Our Ref: SWW046\_response070619\_updated110619

**YSGOL GYMRAEG BRO MORGANNWG**

**THE ERECTION OF EXTENSIONS TO THE SCHOOL FOR A NEW SPORTS BLOCK; DESIGN AND TECHNOLOGY BLOCK; NEW RECEPTION AREA; CREATION OF NEW PLANT ROOM; NEW MUGA AND 3G ALL WEATHER PITCH; THE CREATION OF A NEW COACH DROP OFF / PICK UP AREA**

This letter has been prepared in response to the additional TA comments received 11/06/19 under the document titled **Vale of Glamorgan Highway Authority Observation Sheet (Additional Comments TA Review)**.

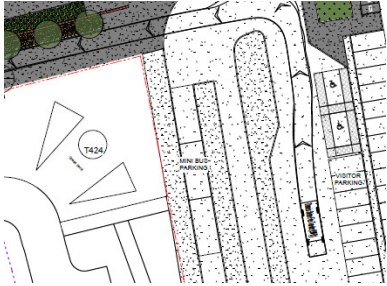
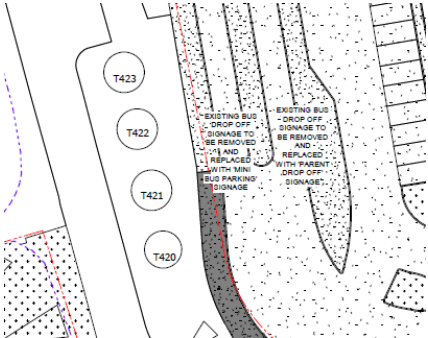
Reference No.	Issue raised	Response
LMH1	<b><u>Signalised Junction A4050</u></b>  While the flows / modal shifts have been considered the report ( items 6.3.2 through to 6.3.5 – see below )	<b>Response to comments on A4050/Barry Hospital and YGBM access signal-controlled junction</b>  The Highway Officer is correct in that the effects of the proposed development have not been modelled in terms of junction

Reference No.	Issue raised	Response
	<p>It would appear that the effects on the junction / envisaged model shifts have not been modelled using the appropriate modelling packages such as Linsig, Transit &amp; Vissim and therefore the Highway Authority cannot ascertain the real time effects on the junction such as phasing / timings / que lengths</p>	<p>capacity assessment. The impact of the proposed development in the Transport Assessment has been thoroughly considered in terms of percentage changes in traffic flows between a future year 'without' and 'with' development scenario. The 'without' development scenario is as per the existing situation, but with the addition of background traffic growth.</p> <p>The 'with' development scenario includes the increase in pupil population associated with the proposed development as follows:</p> <ul style="list-style-type: none"> <li>• Existing: 1,133 pupils (1,015 primary / secondary and 118 sixth form) (number on roll at time of assessment)</li> <li>• Proposed: 1,660 pupils (1,410 primary / secondary and 250 sixth form).</li> <li>• Increase: 527 pupils (395 secondary and 132 sixth form).</li> </ul> <p>The TA forecast that the increase in pupil numbers from 'existing' to 'proposed' will result in an increase in traffic flows of 12% at the junction during the AM and PM peak hours. It should be highlighted that part of the proposed increase in pupil numbers is already consented; the school already has consent for a total of 1,361 pupils. Therefore, 228 of the assessed 527 pupils can already be considered to be consented and acceptable to LHA/LPA.</p> <p>As such, it has been considered reasonable to update the 'without development' baseline to include the full consented number of pupils at YGBM (1,361 pupils). This provides for a more appropriate comparison between what is 'consented' (i.e. already accepted by the LHA/LPA) and 'proposed' development. The 'without development' scenario also now includes traffic associated with the planning application for Whitmore High School; this is a live planning application and, under best practice guidance, development that can be reasonably expected to come forward (i.e. has a validated planning application or is consented) should be included in assessments as 'committed development'.</p> <p>The table set out in <b>Appendix 1</b> of this letter sets out the derivation of traffic flows for the revised 'without' and 'with' scenarios at the junction, and provides an update of the percentage impact assessment.</p> <p>The table shows that the proposed development will result in an increase in traffic entering the junction of 5% during the AM and PM peak hours, when compared with a baseline future year scenario that includes consented/committed development. This level of increase is not considered to require junction capacity assessment and within the realms of daily variation.</p>

Reference No.	Issue raised	Response
		<p>The proposals for YGBM will also result in buses relocated to and sharing with WHS and utilising the WHS access instead of the YGBM access. There are currently 14 buses to/from YGBM; this equates to the removal of 28 vehicle movements at the signal-controlled junction during the AM and PM peak hours. When these are removed from the '2021 With Development' (Column 6) traffic flows, the percentage change (Column 7) reduces to 4% during the AM and PM peak hours. In terms of capacity assessment, buses can equate to two or more standard car vehicles, (Passenger Car Units) therefore the effect of removing these will improve capacity</p> <p>It is on the basis of the updated analysis that no further assessment is considered to be required. In addition to this, the answer to the question around ascertaining the 'real time effects on the junction' have been established in that there will be minimal changes which is likely to be immaterial. The removal of large PSV movements is likely to be more noticeable in day to day operation.</p>

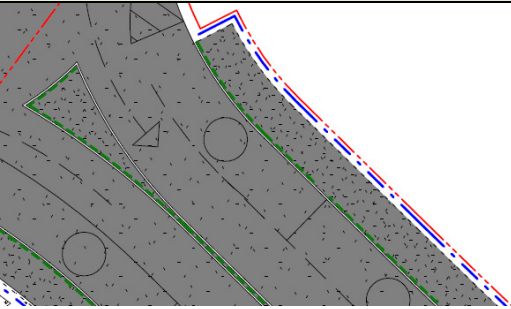
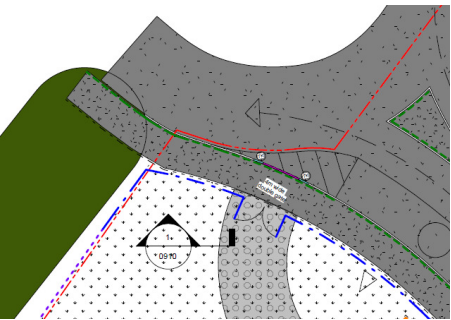
Reference No.	Issue raised	Response
1	In accordance to the Council's Car Parking Standards for education establishments a requirement of 1 space per member of teaching staff, 1 space per 2 ancillary staff, 1 space per 20 six form students and 3 visitor spaces plus bus parking facilities as required. As a result of the above, the Parking Standards' requirement for 74 teaching staff (74 spaces), 35 ancillary staff (18 spaces), 250 sixth form students (13 spaces), and visitors (3 spaces) is therefore for the provision of 108 parking spaces. The new proposal	The visitor parking and disabled parking spaces are now shown on the updated drawing " <b>ASL- 00- ZZ- DR- L- 0900 rev P17</b> ". Extract below:

Reference No.	Issue raised	Response
	<p>provides car parking for 122 parking spaces which is appropriate. However, the location of the visitor and disabled parking needs to be highlighted on the general arrangement.</p>	
<p>2</p>	<p>I note from a site visit that the school currently has 3 minibuses for personal use and larger parking bays will be required to store these vehicles when the existing car park outside the existing reception is removed and suitable turning facilities</p>	<p>The revised external works drawing <b>“ASL- 00- ZZ- DR- L- 0900 rev P17”</b> now shows an area for the school mini bus parking and notes to state that signage around this space is to be changed.</p> <p>Extract below:</p> 
<p>3</p>	<p>The Transport Assessment indicated that the existing bus drop off bay will now be utilise for parent drop off. As a result the existing signage will need to be changed accordingly.</p>	<p>The transport assessment has been revised (<b>TA_V5.4 issue Full</b>) to reflect this requirement.</p> <p>The revised external works drawing <b>“ASL- 00- ZZ- DR- L- 0900 rev P17”</b> now states that the existing signage is to be removed and new signage will be erected</p> <p>Extract below:</p>
